DATE: July 25, 2025
TO: ALL CONTRACTORS
FROM: ROBBIE STROM
PROJECT: ALOE BAY HARBOR TOWN PHASE II – PACKAGE I DESOTO AVENUE BOARDWALK & BULKHEAD #M1A101-ABHT FOR THE TOWN OF DAUPHIN ISLAND GMC PROJECT NO. CMOB220084(1)
RE: ADDENDUM #1

ADDENDUM NUMBER 1

ALOE BAY HARBOR TOWN PHASE II – PACKAGE I DESOTO AVENUE BOARDWALK & BULKHEAD #M1A01-ABHT
FOR
TOWN OF DAUPHIN ISLAND
GMC PROJECT NO. CMOB220084(1)

2. Revisions to Plans

G2 sheet of

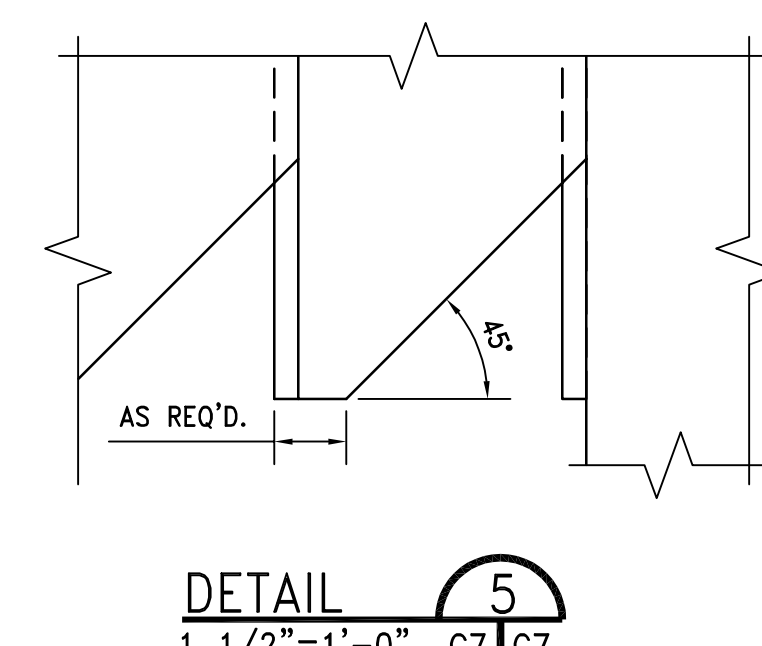
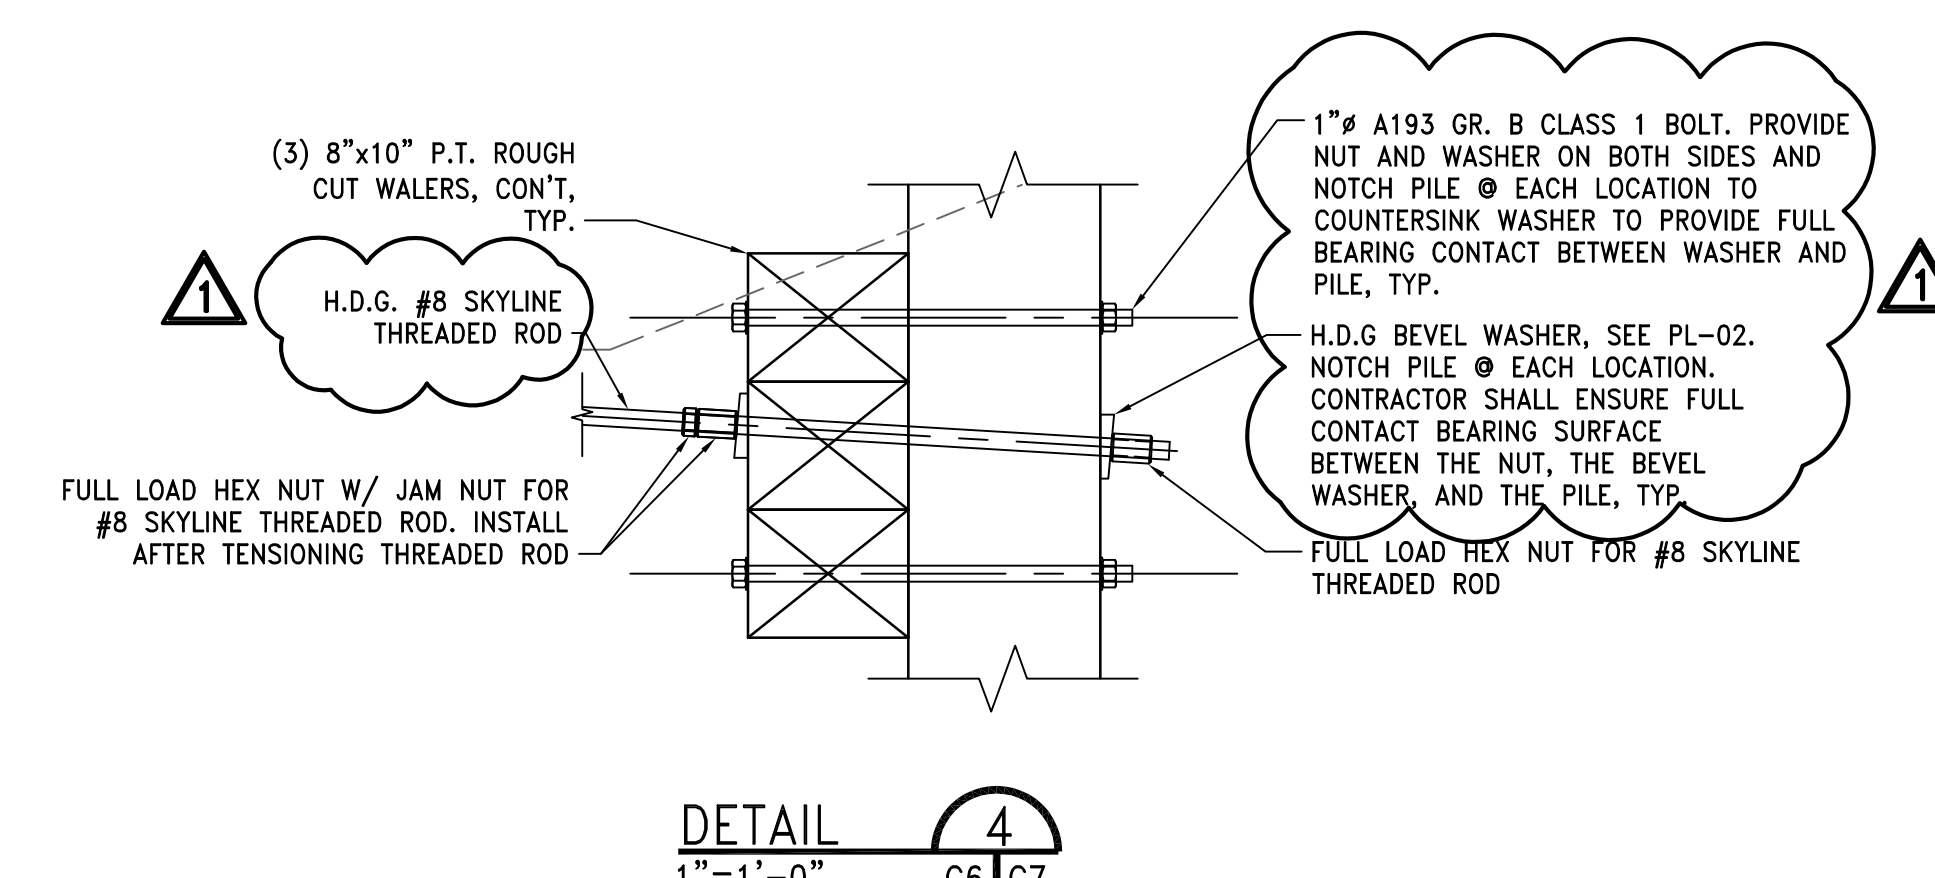
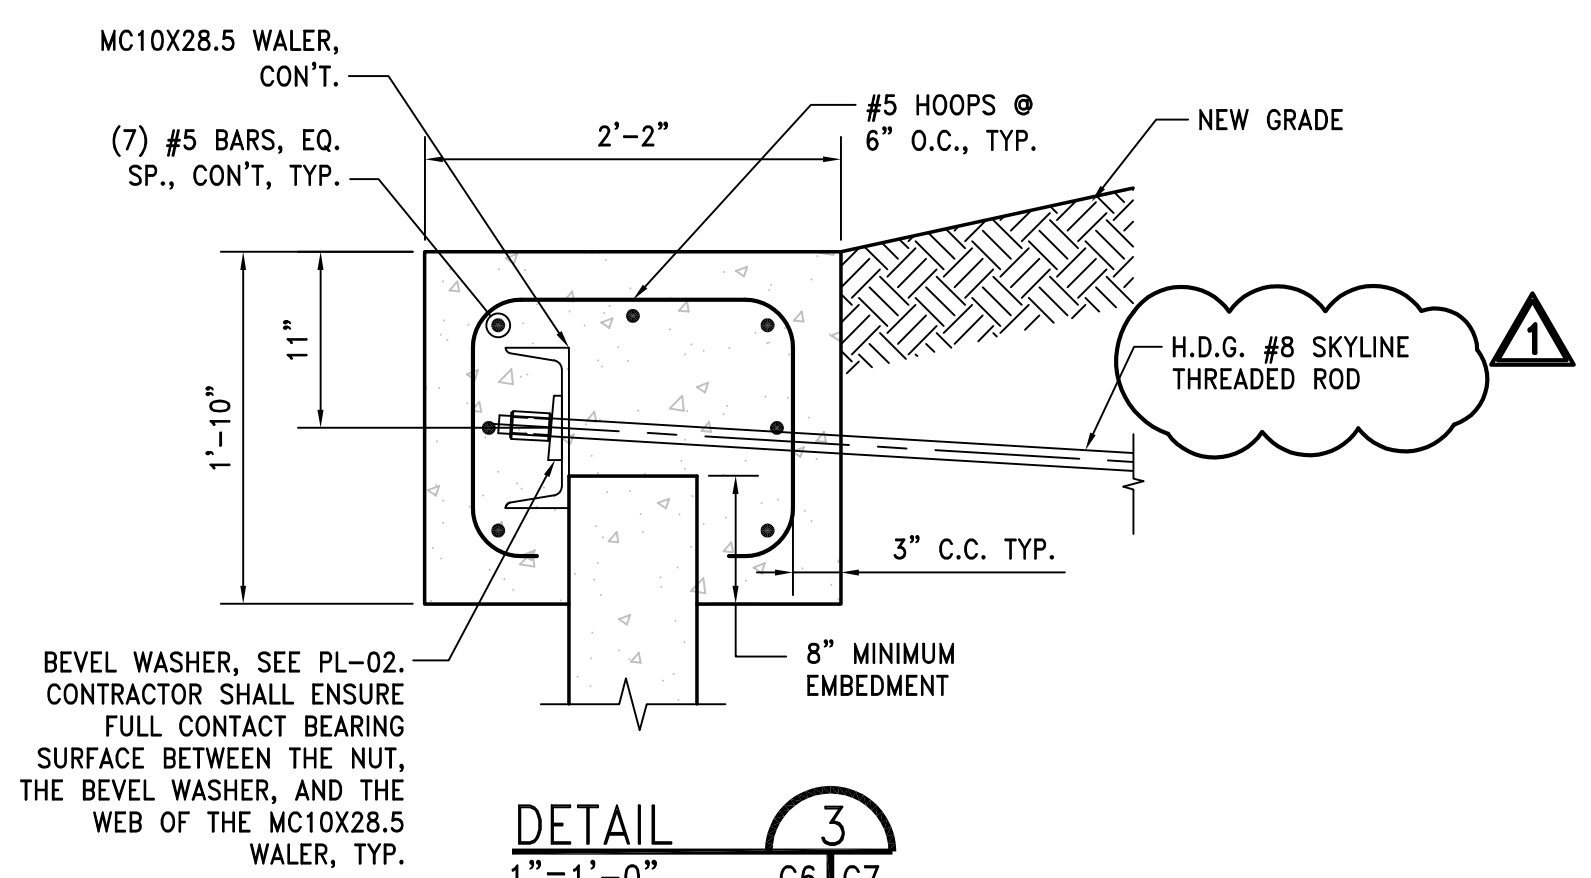
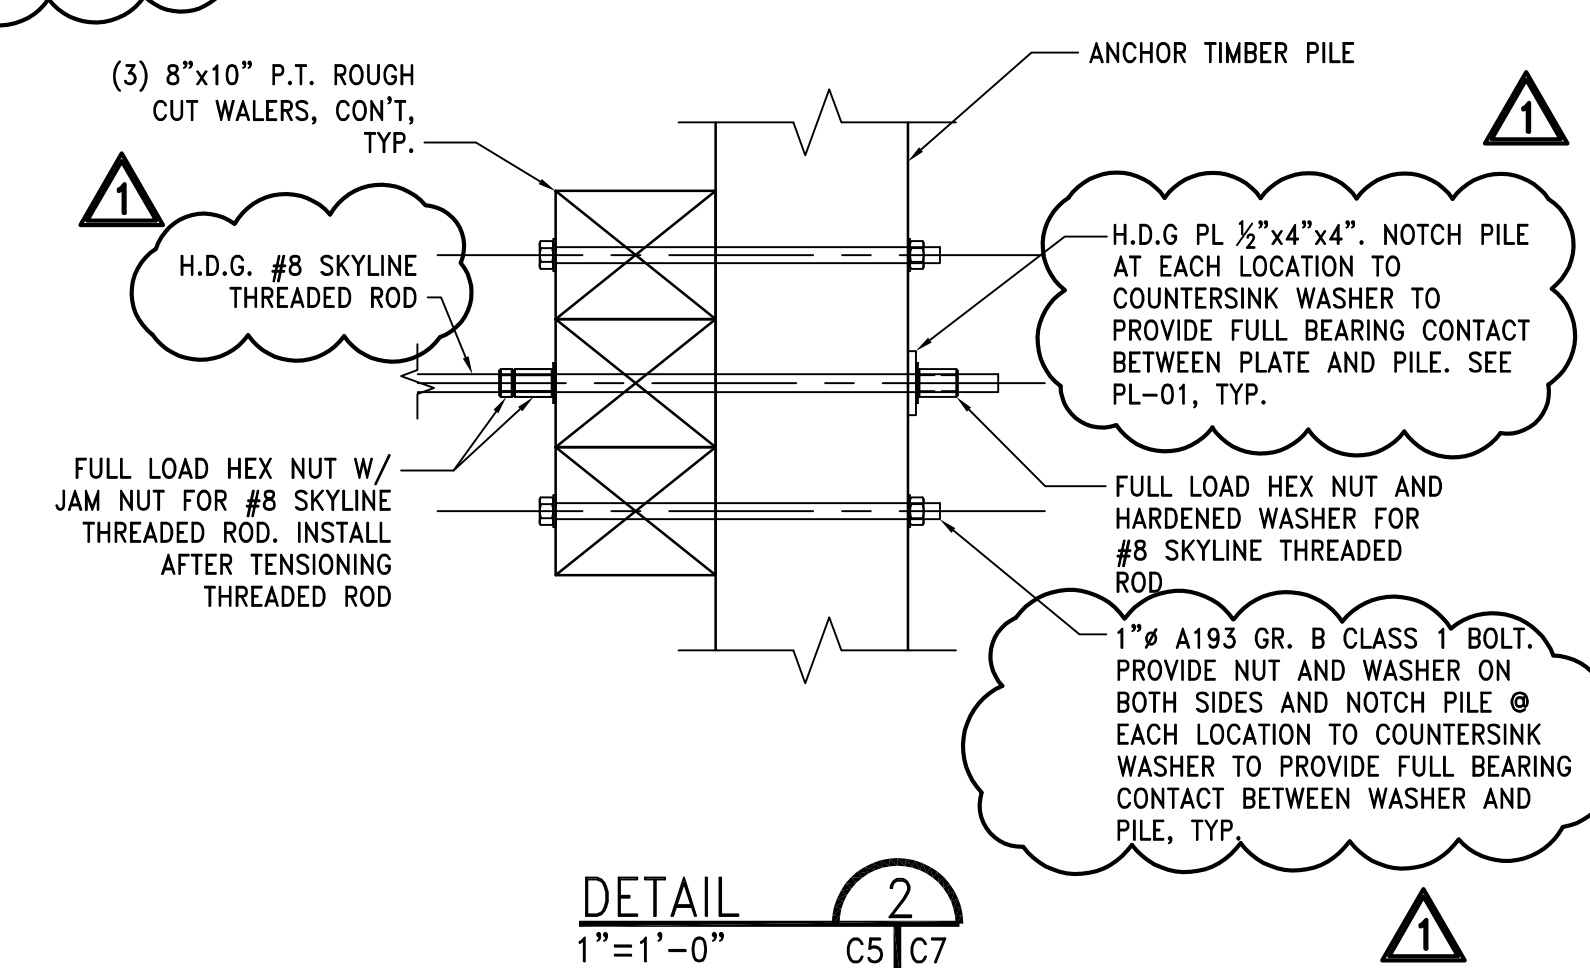
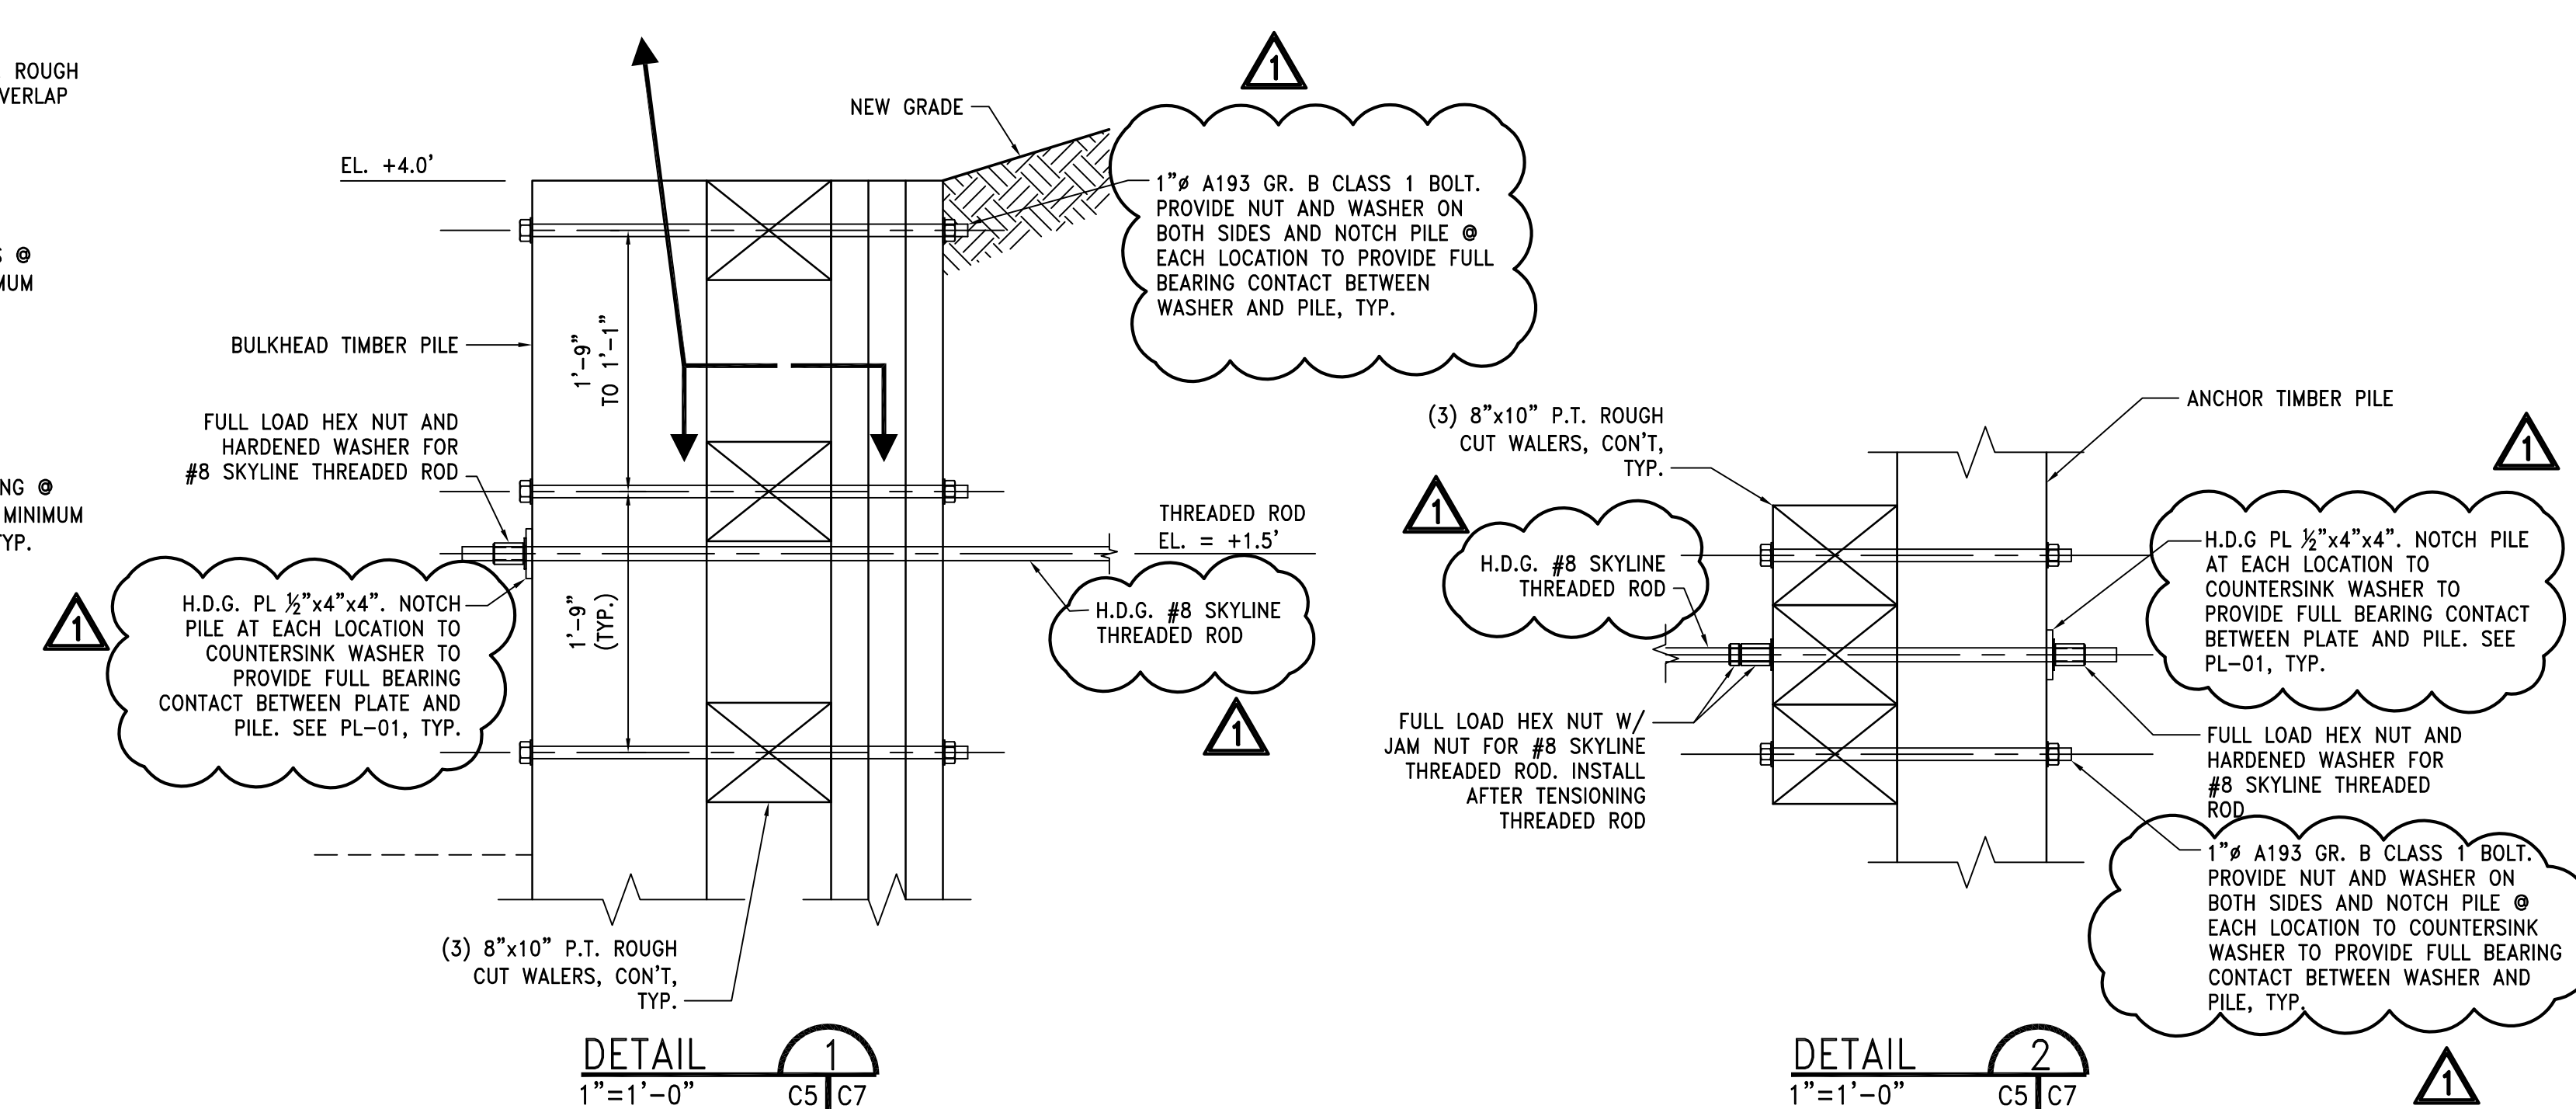
- 4.2 **Are pile templates a requirement for the timber pile operations as stated on G2 #2 under wood piling?** Not required but a good idea. Piles shall be in correction location.

- 4.3 **Will vibratory driving be allowed for timber pile and wakefield sheeting? If so it will not be possible to provide the information on #6 - #9 under wood piling on G2.** Vibratory Hammer is acceptable.
